UNITED STATES PATENT AND TRADEMARK OFFICE

10/802,641

DETAILED ACTION

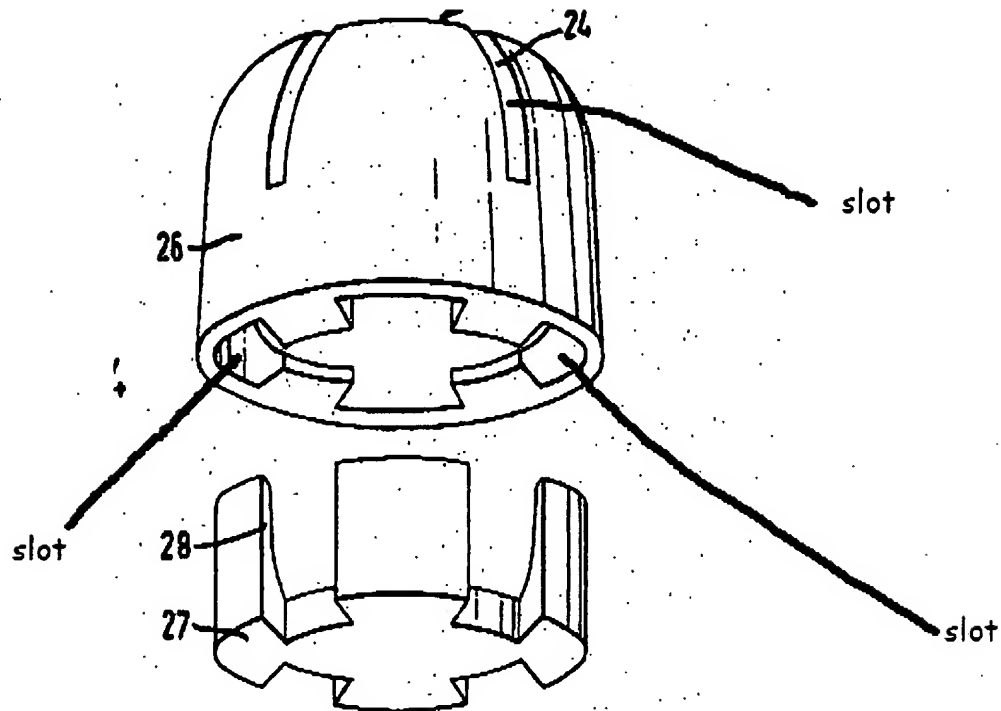
Farrant discloses a bearing with a stud member (13) with a stud head and a housing (11) with a central bore comprising:

An annular bearing body (26) that seats between the housing and the stud head, wherein the inner surface includes at least three radial slots (see fig below), two of said radial slots having a first radial depth which differs from a radial depth of each other radial slot.

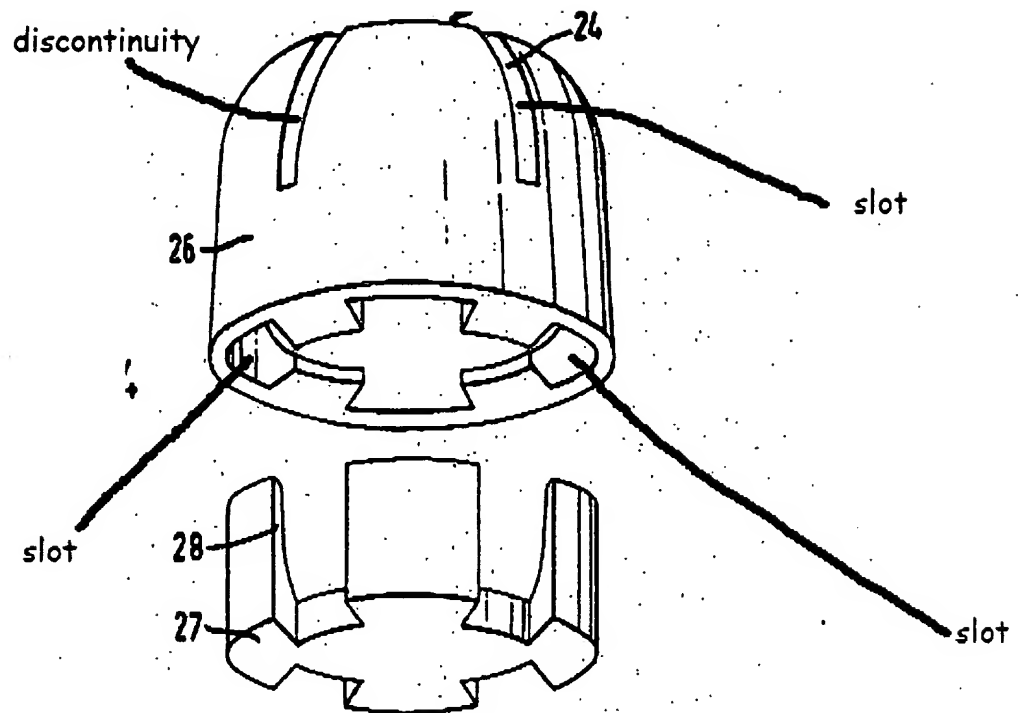
Regarding claim 2, the radial slots are symmetrically disposed about a vertical axis.

Regarding claim 3, the radial slot dimensions and placements are configured to minimize stresses.

Regarding claim 4, the radial slot dimensions and placements are configured to equalize stresses.

Regarding claim 5, the annular bearing body includes a discontinuity.

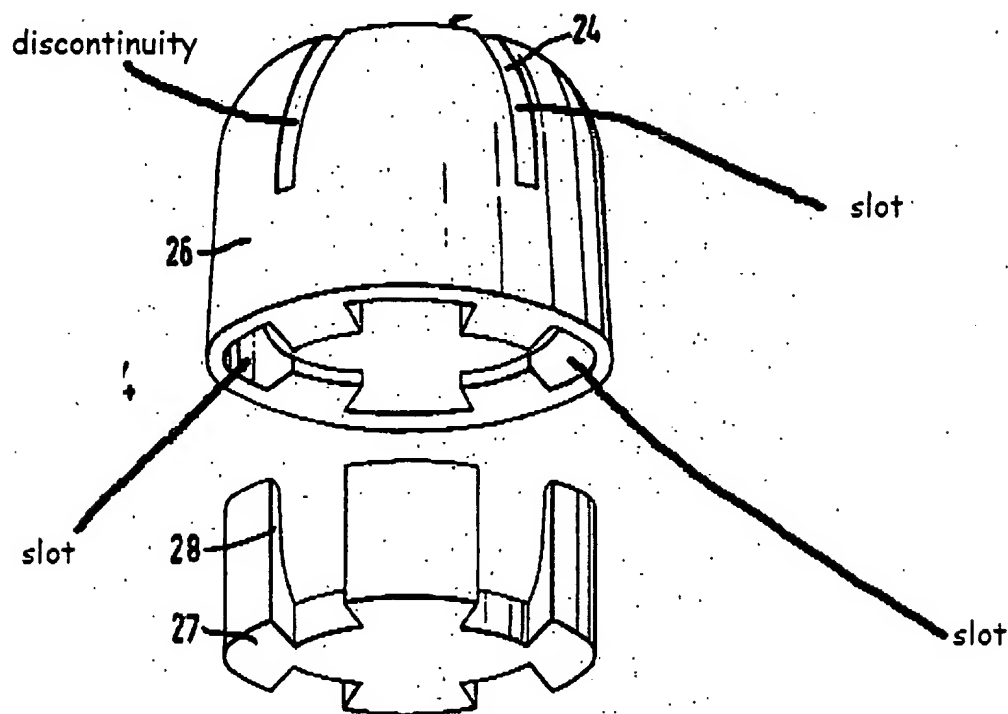
Regarding claim 6 and 7, an axial plane bisects the annular bearing into first and second mirror image portions.

Regarding claim 8, a radial depth associated with each radial slot in each of the first and second mirror image portions increases for each radial slot from a minimum radial depth in a first radial slot to a maximum radial depth in a last radial slot.

A bearing insert (26) disposed between the housing and the stud head, and including at least three radial slots and a discontinuity (see fig below), wherein
